ADDENDUM NO. 2

for
**STEM LAB ALTERATIONS AND RENOVATIONS AT
CLEARVIEW REGIONAL MIDDLE SCHOOL**
located at 595 Jefferson Road, Mullica Hill, NJ 08062

Issued: November 1, 2023

FVHD PROJECT #5162C

TYPICAL OPENING DETAIL AT ROOF UNDER NEW HVAC CURB
 NOT TO SCALE

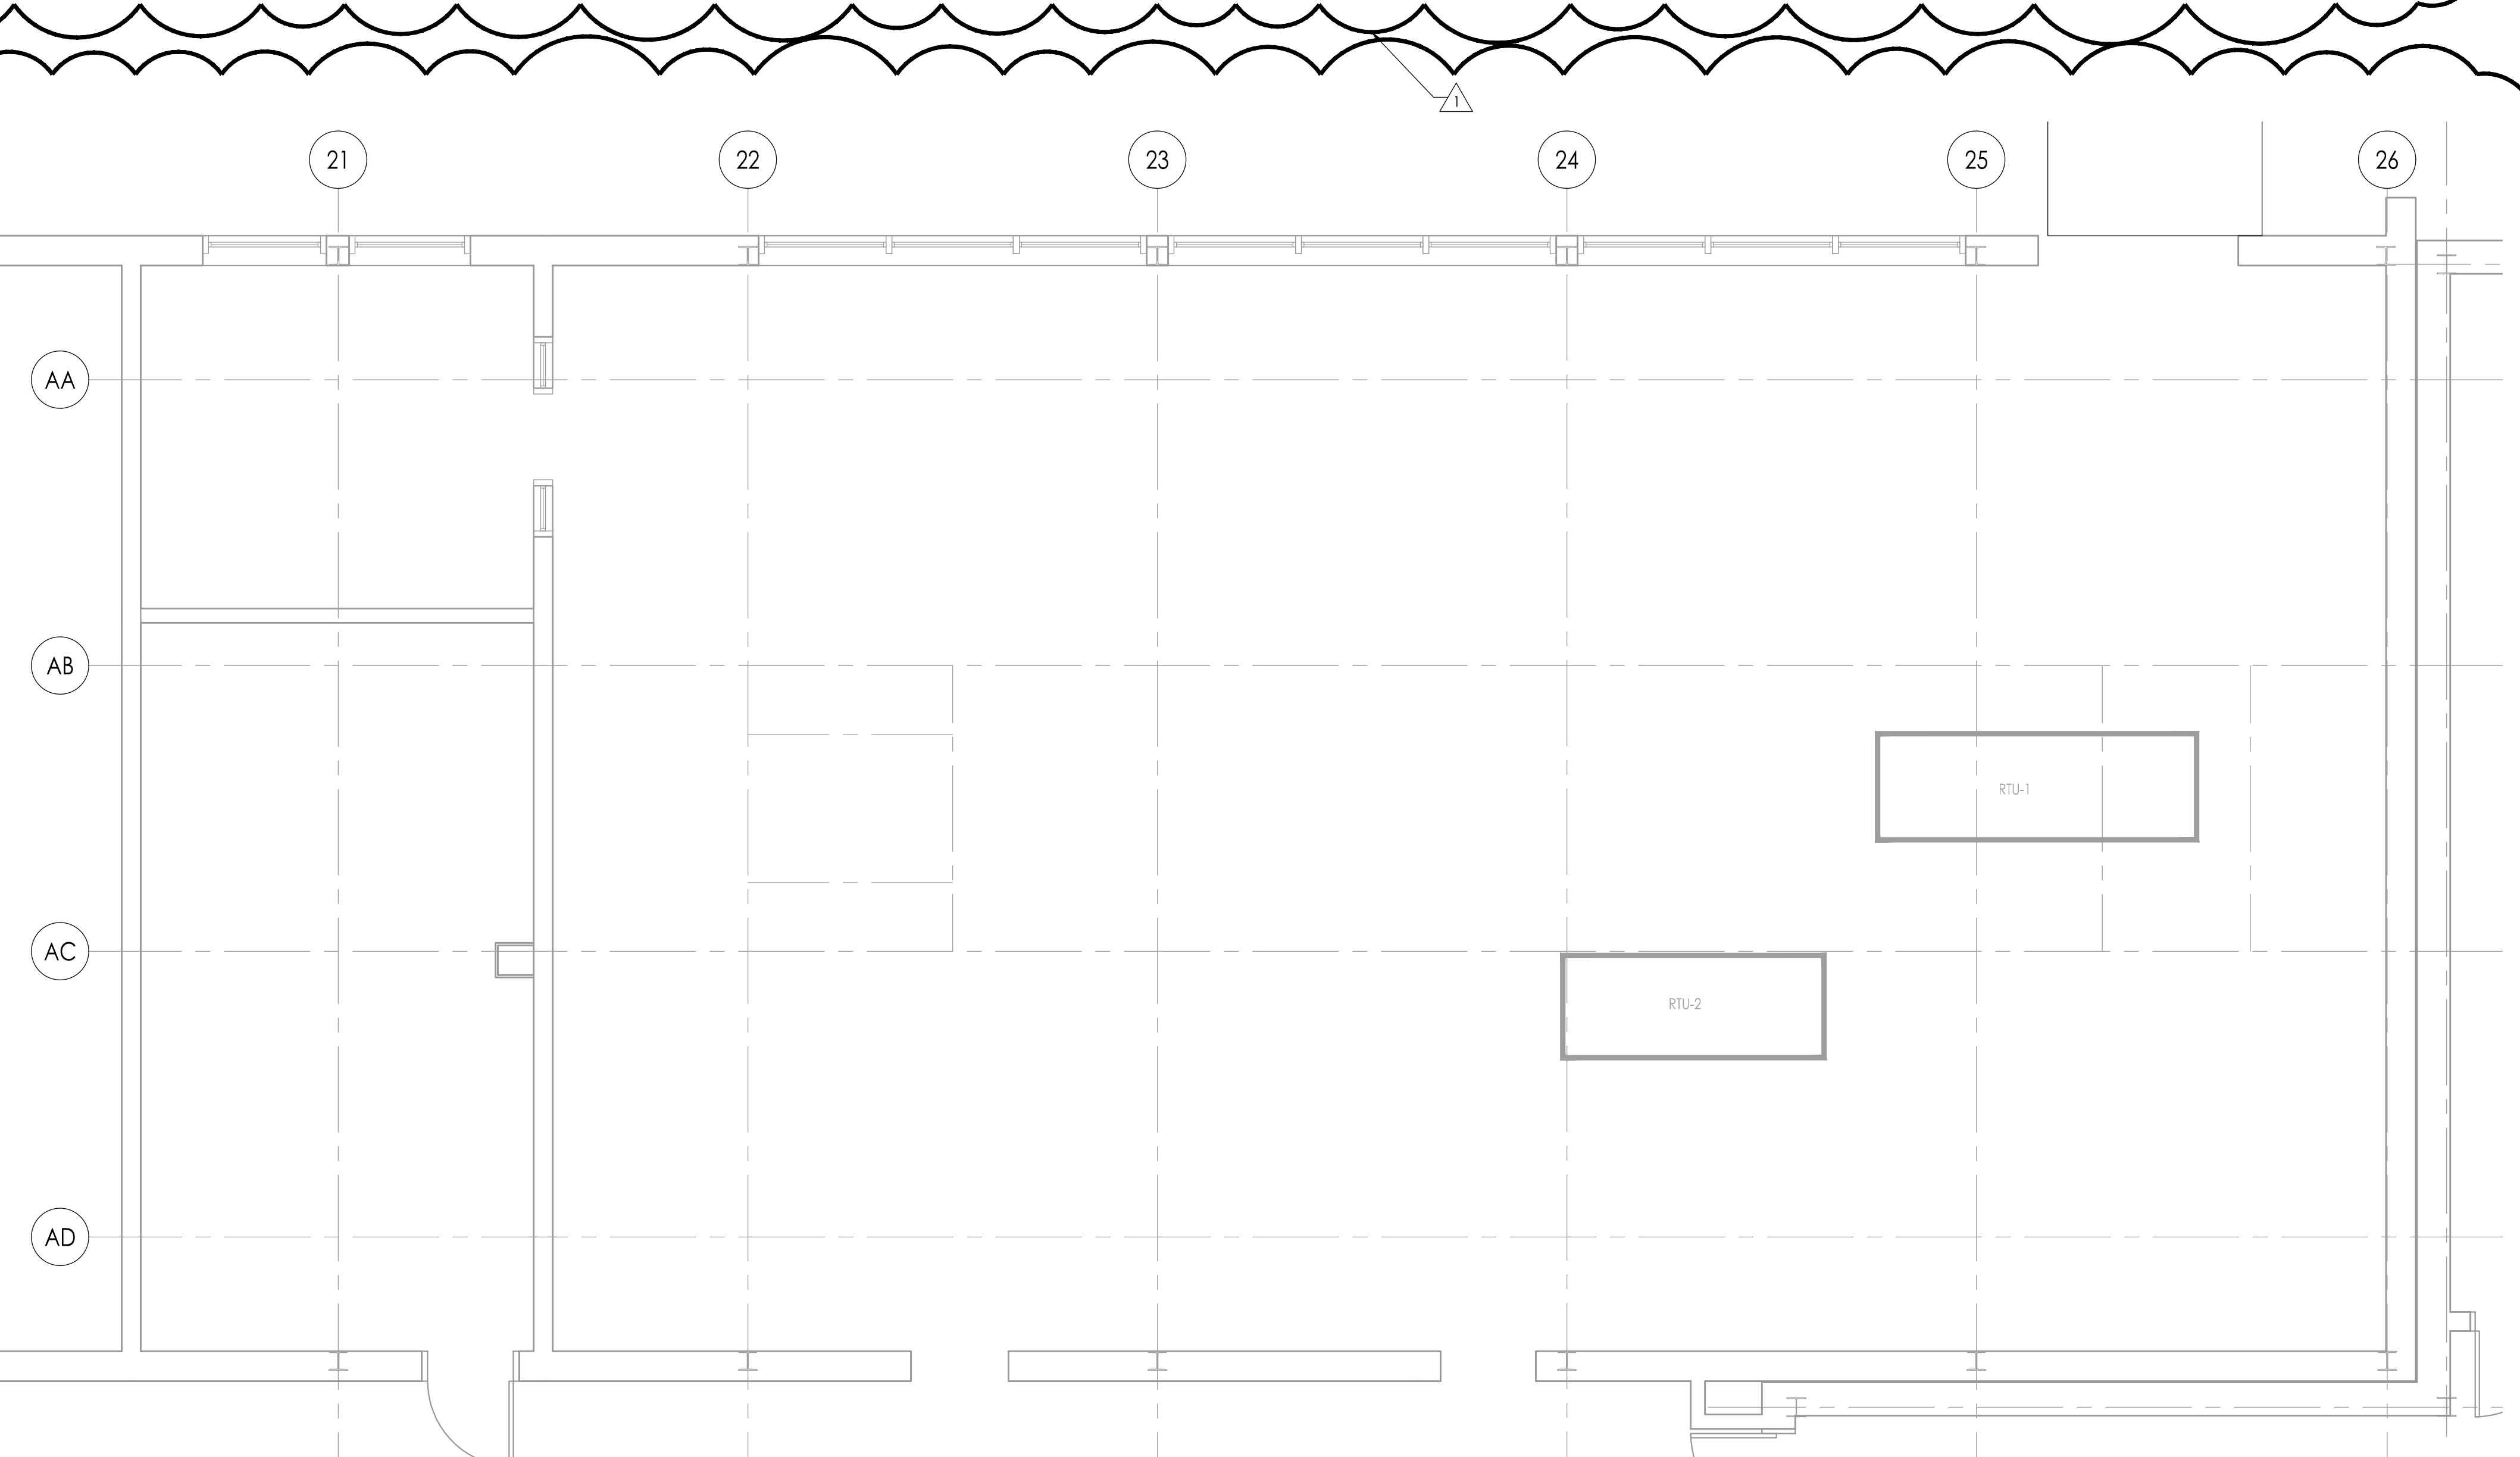
1. Question: Please provide further detail regarding the Structural Steel for the Duct Openings from the Roof, such what the existing framing is, the size of the openings, locations, do these openings span more than one bay of existing framing, etc.

2. Question: They show a typical detail for a roof frame, but don't show where the openings are located.

3. Question: They show 2 new RTU's but nothing tells me what openings, or if any are required. If anything is required here, we need to know what the existing framing is, what the access is, the size of the openings, locations, do these openings span more than one bay of existing framing, etc.

Response: The location of the openings are the responsibility of the contractor to coordinate and verify in field. See "Typical Opening Detail at Roof Under New HVAC Curb" on drawing A301 for new framing requirements.

Response: Location of the openings are the responsibility of the contractor to coordinate and verify in field with roof and mechanical plans. Refer to drawing A301 for approximate location of the openings and approximate location over the existing structural framing.

Response: Access to the roof is to be coordinated with Owner. Refer to drawing A301 for approximate location of the openings and approximate location over the existing structural framing. See "Typical Opening Detail at Roof Under New HVAC Curb" on drawing A301 for new framing requirements.

1 PARTIAL FIRST FLOOR PLAN - HVAC NEW WORK
 H201 SCALE: 1/4" = 1'-0"

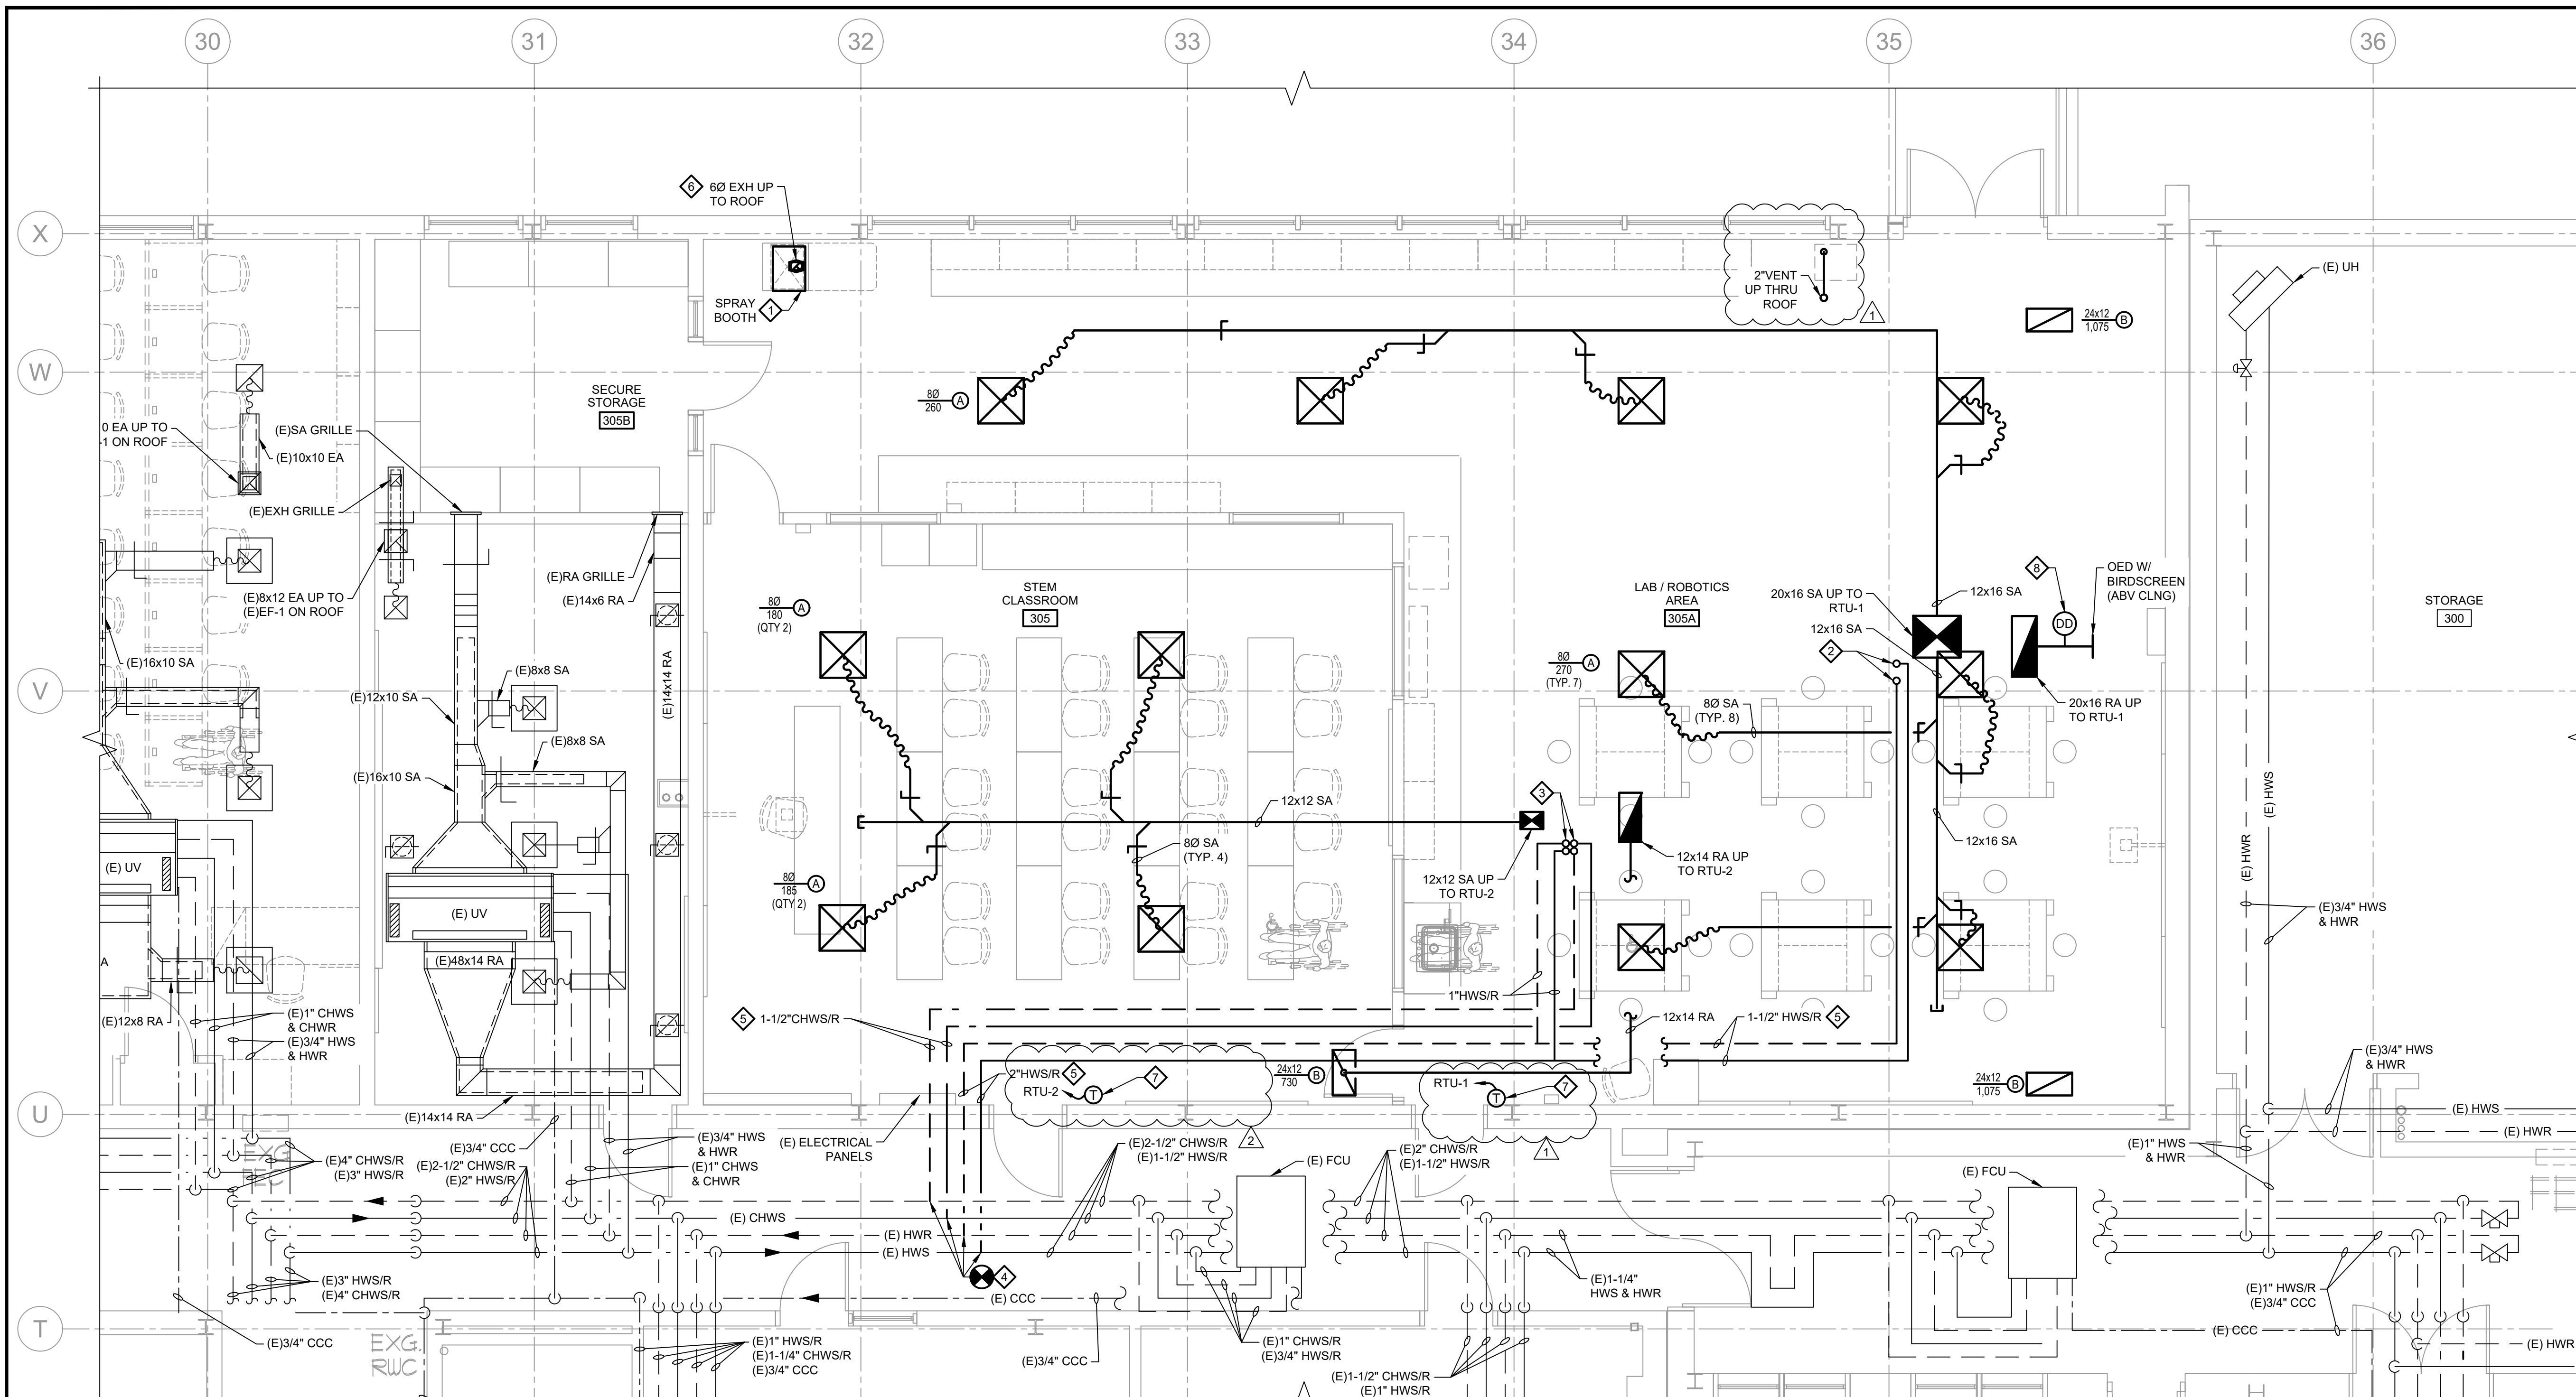
3. HVAC TRADE
 - 3.1 CLARIFICATIONS:
 - 3.1.1. None.
 - 3.2 ERRATA IN THE SPECIFICATIONS
 - 3.2.1. None.
 - 3.3 ERRATA ON THE DRAWINGS
 - 3.3.1. Drawing H201 – HVAC First Floor New Work Plan: Slide RTU-2 T-Stat location closer to door to avoid conflict with new wall mounted white board.
